# COIN CIRCUS “Big Fin Version”

## CONVERSION INSTRUCTIONS - Case of “MIX FIN” -

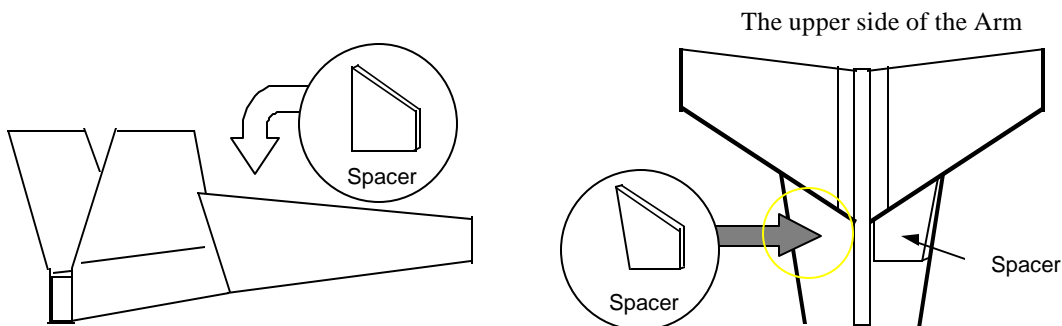
- 1) Take off screws and remove the regular fin from Arm #1(Man) and Arm #3(Tiger). Then replace the “**BIG FIN**” on the Arm in exact location.

- 2) Put on “**SPACERS**” inside the Arm as
